Bulletin No. 1052 Issue 1 January, 1936

PARTS
SIX UNIT PERFORATOR

789££ Issue 3 July, 1956

CHANGES AND ADDITIONS TO THE FOLLOWING PARTS BULLETIN

BULLETIN NO. 1080B, ISSUE 1, PAGE 5
BULLETIN NO. 1064B, ISSUE 2, (BELL) PAGE 5
SINGLE MAGNET REPERFORATOR (RPE)
(MODELS 14 AND 20 NON-TYPING)
BULLETIN NO. 1052B, ISSUE 1, PAGES 2 AND 3
(SIX-UNIT PERFORATOR (MPE)

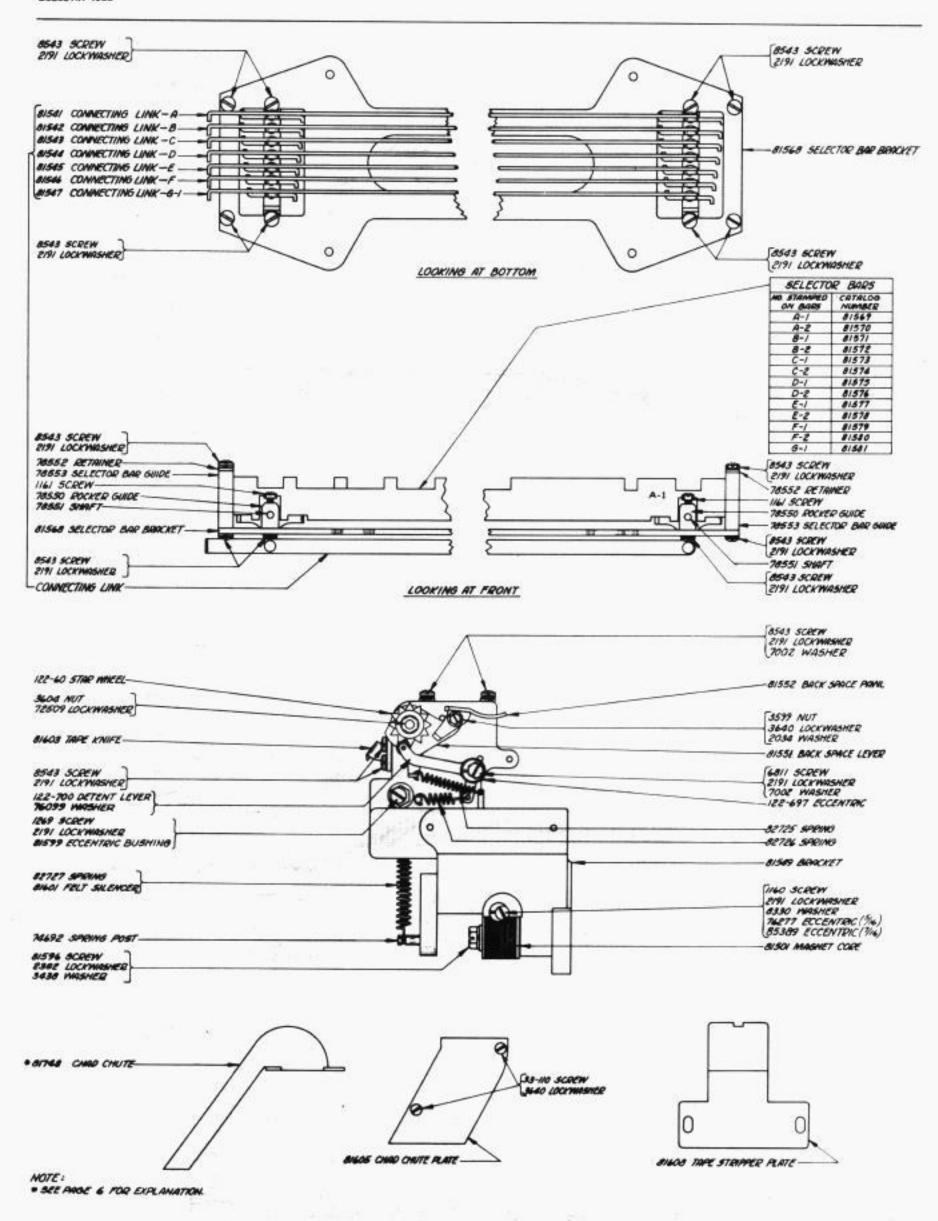
To provide a means for identifying the beginning or the end of a fully perforated six-unit tape the 81603 tape knife has been replaced by a 123581 - tape knife. The 123581 tape knife cuts a triangular notch which produces a small flag on the trailing edge of the tape as it is torn off, and a corresponding notch on the leading edge.

NOTE: Part No. 87603 referred to in Bulletin No. 1064B is in error. This number should be 81603.
